S E R V I C E N O T E

4396A Network/Spectrum Analyzer

Firmware Update Procedures

4396A-4 Figure 1

Figure 1.   Bootloader Screen

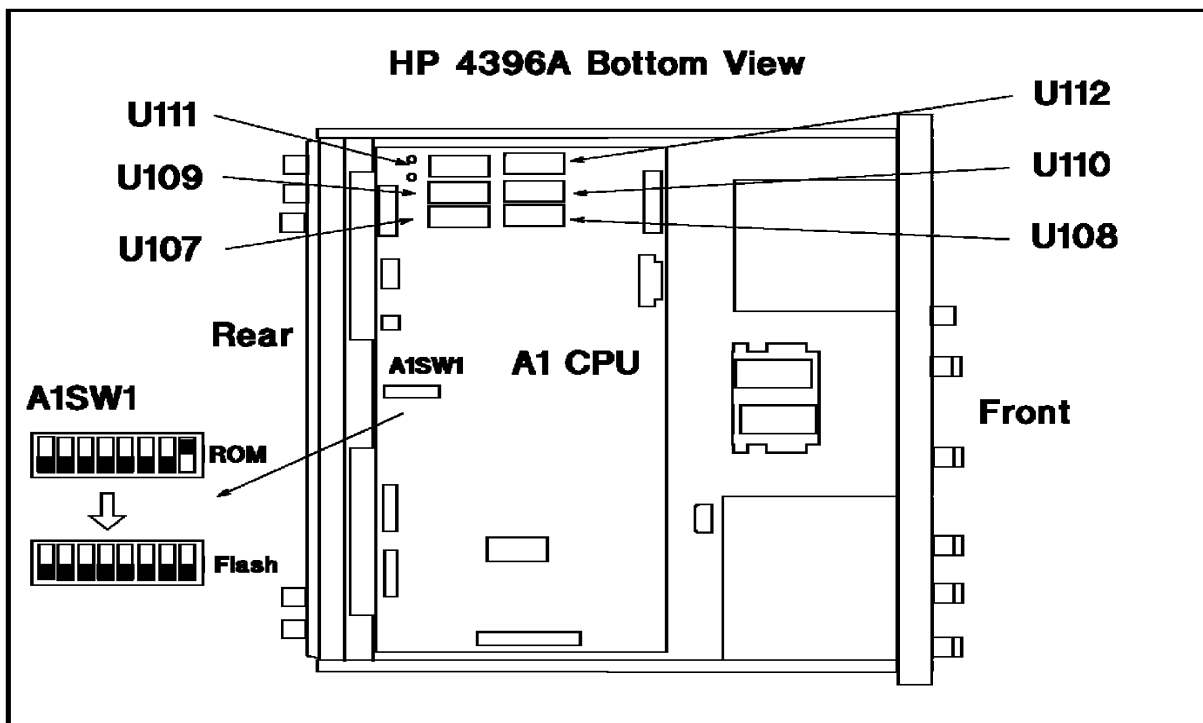
A1 CPU Modification Procedure to flash memory version
  1. Remove the bottom cover from the unit.
  2. Change the bit switch A1SW1 settings as shown in Figure 2.

3. Remove the six programmed ROMs (A1U107 through A1U112) from IC sockets on the A1 CPU. The location of the sockets are shown in Figure 2.
4. Install the six flash memories in to the IC sockets A1U107 through A1U112.
5. Assemble the bottom cover.
6. Turn the unit powe on. Then the Bootlloader appears as shown in Figure 1.
7. Install the desired firmware by using the firmware installation kit.
